COUNCIL ASSESSMENT REPORT

Panel Reference	2018SCL070
DA Number	BD.2015.193
LGA	Burwood
Proposed Development	CI 4.55 Modification application for the variation to an existing consent by the addition of an additional 2 stories (895m2 of floor space – 8 units) to the existing approved development under construction.
Street Address	39-47 Belmore St Burwood
Applicant/Owner	Applicant: Tom Hu - Kapau Holdings
Date of DA lodgement	4 June 2018
Number of Submissions	Two (2)
Recommendation	Approval subject to Conditions
Regional Development Criteria (Schedule 4A of the EP&A Act)	Original Development Cost Greater than \$30M – CI 4.55 (2) Application
List of all relevant s79C(1)(a) matters	<ul style="list-style-type: none"> • BLEP 2012 • BDCP • Existing VPA, not affected • Privacy • Overshadowing
List all documents submitted with this report for the Panel's consideration	Architectural plans Architectural Design Report Waste Management Plan CI 115 Explanation of Amendments and Impacts Traffic & parking Report Section 4.55.Advice

Report prepared by	Planning Ingenuity (on behalf of Burwood Council)
Report date	21 September 2018

Property: 39-47 Belmore Street, Burwood
Lot 100 DP 1185255
DA No: B

Figure 8: Modified east and west elevations (Approved height shown at red line)

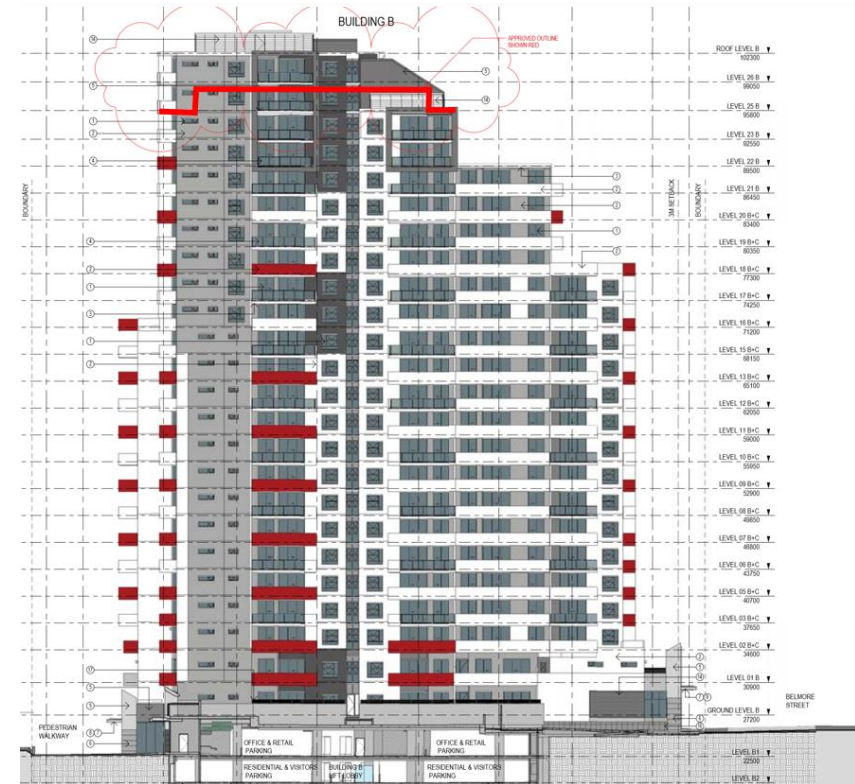
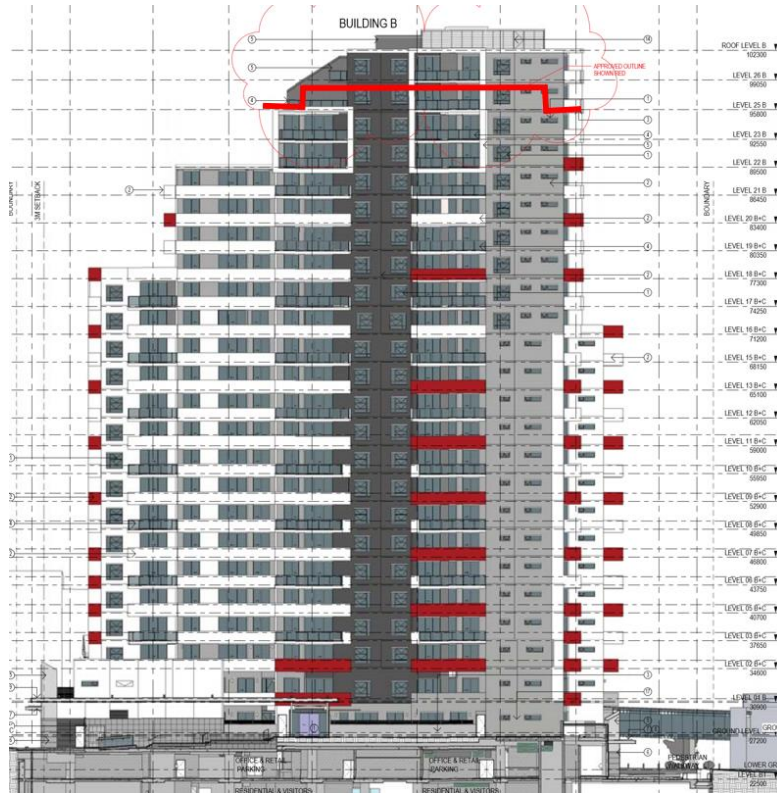
With respect to the additional 2 levels on Building B, this is also considered to be substantially the same development as that which has been approved.

Quantitatively, the increased GFA is 895m² which amounts to a 1.85% increase over the approved GFA. The increased HOB is +6.4m or 8.84% over the approved HOB. These numeric changes are,

given the scale of the development, considered to be minor in nature and do not affect the overall impact of the development. Nor does it materially change the land use or intensity of the development beyond what has originally been approved.

Figure 9: Modified north elevation (Approved height shown at red line)

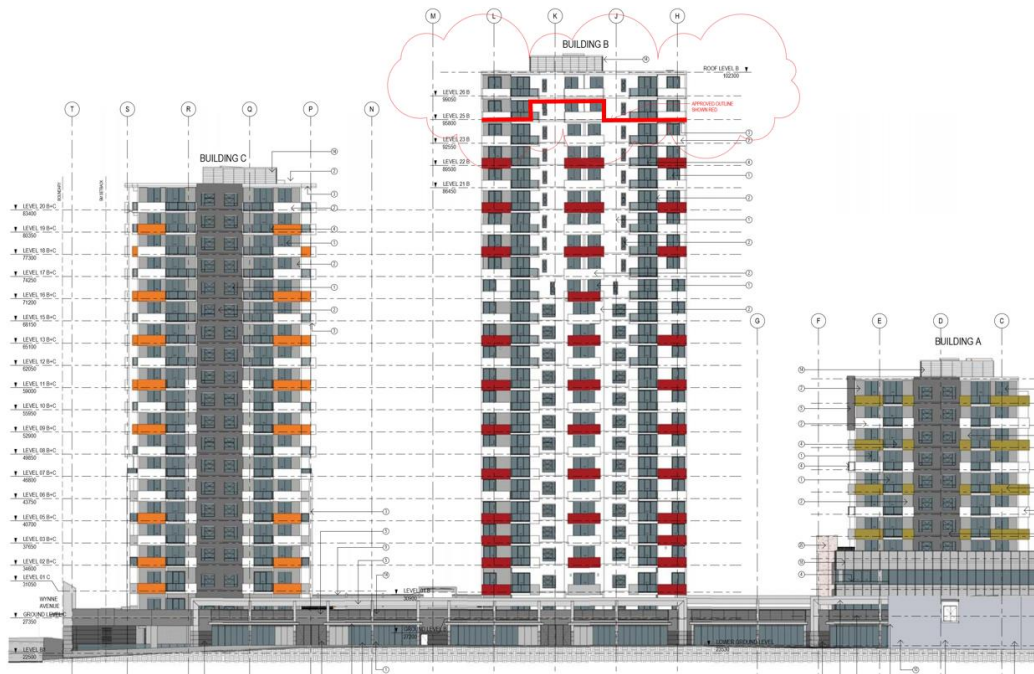
Qualitatively, the additional height and bulk has been distributed in a recessive form that is not overly visible from the immediate vicinity of the site, and it is distributed below the 330 DCP southern height plane, as shown in Figure 13 below.

Whilst the 60m height place is breached, the 330 height plane is complied with to step the additional levels back. The 60m height limit breach was considered acceptable under the previous approval and it is considered that the additional 2 storeys does not introduce any additional impacts beyond what was previously assessed.

Figure 14: Extract from BLEP 2012 Floor Space Ratio Map

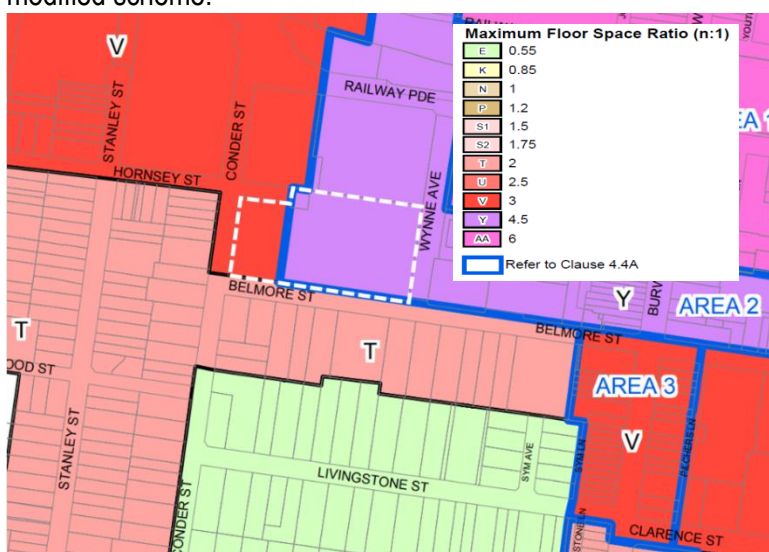
The total permissible GFA under BLEP 2012 over the entire site following amalgamation of the additional land is 42,750m². The proposed total GFA for the entire site following the modifications is 49,356m². The difference between these two GFA amounts is 6,606m². The exceedance as a percentage of the maximum permitted GFA for the entire site is equivalent to 15.45%.

This is an improvement on the approved figures as the additional land allows for extra GFA to be attributed the development site. The exceedance therefore reduces from 15.96% to 15.45% under the modified scheme.

The modified scheme includes additional site area along with additional GFA. Although still an exceedance, the non-compliance is now less than the approved scheme.

Figure 15: Shadow analysis, 9am Winter Solstice

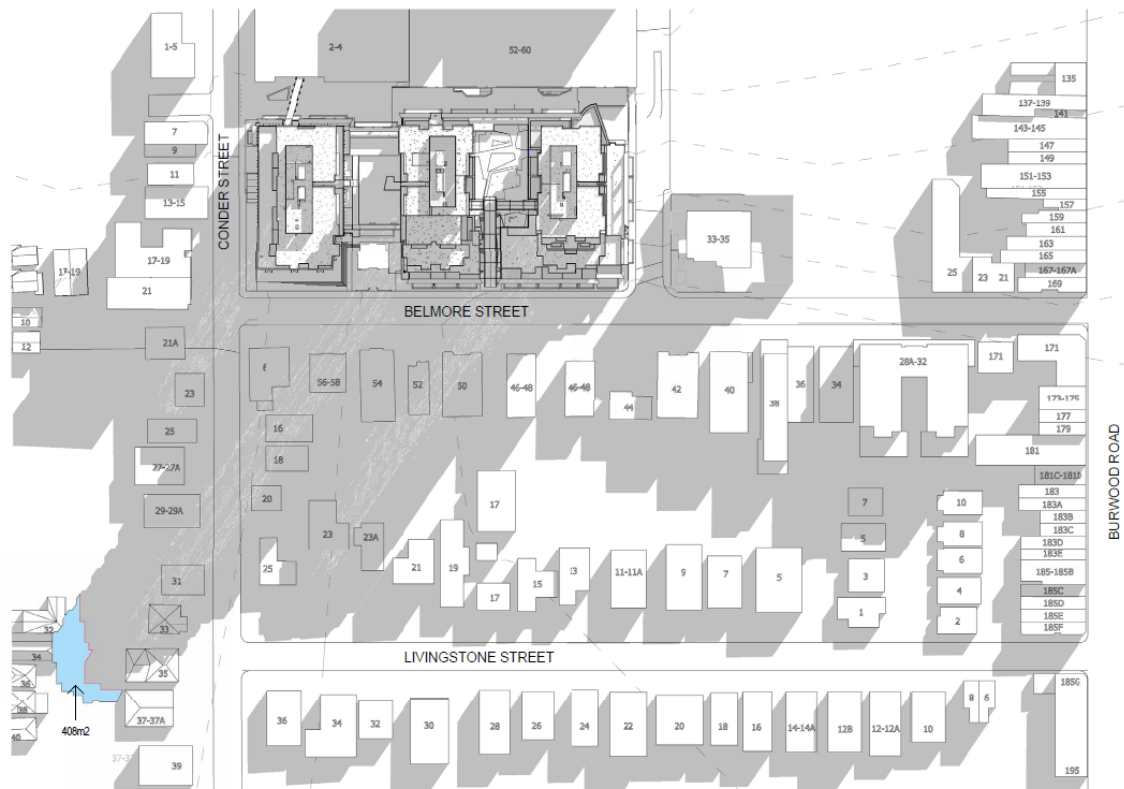
At 9.00am the additional shadow impact of 408m² falls into the backyards of Nos.32, 34, 36, 37 and 37A Stanley Street. Due to the slender form of the proposed additional levels on Building B, the shadows move quickly and by 9.30am have moved clear of these areas.

After 9:30am the previous shadow of 408m² has moved considerably, creating shadows mostly on the roofs of No. 29, 29A and 31 Conder Street. By 9.45 the shadows fall on the street and by 10am are on the opposite side of the street.

The additional shadow impact is considered negligible and of a similar impact to that which was assessed previously. The shadow is fast-moving through the day with no individual property affected for a significant period of time. Therefore the modification is considered acceptable in terms of overshadowing.
